## Pressure Sensors

### Notice of Model Change

Fig.1 External Dimensions

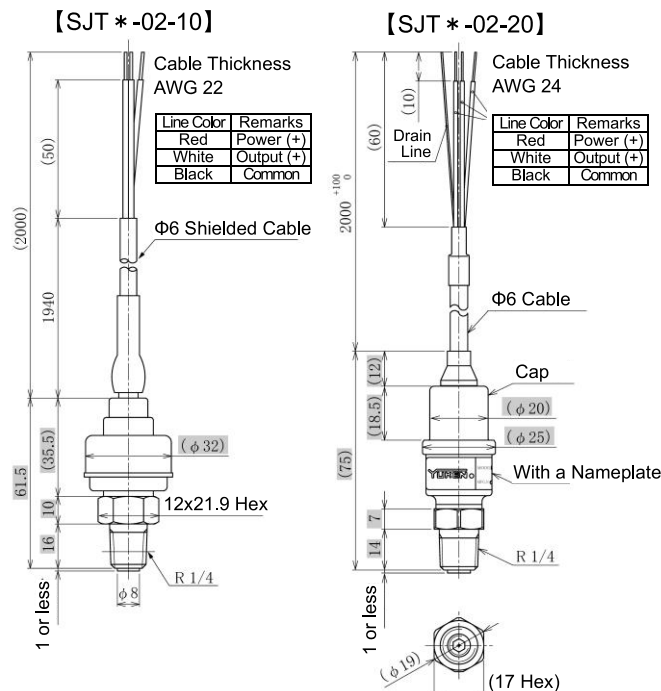
- The design number will be changed from 10 to 20.
- The output range is shown at a supply voltage of 5.00 V. The output is proportional to the supply voltage.
- The sensor connection diameter (R1/4) is the same for the old and new models, but the external dimensions are different. See Figure 1 for details.

Note: Shaded area in the figure...Dimensions have been changed.
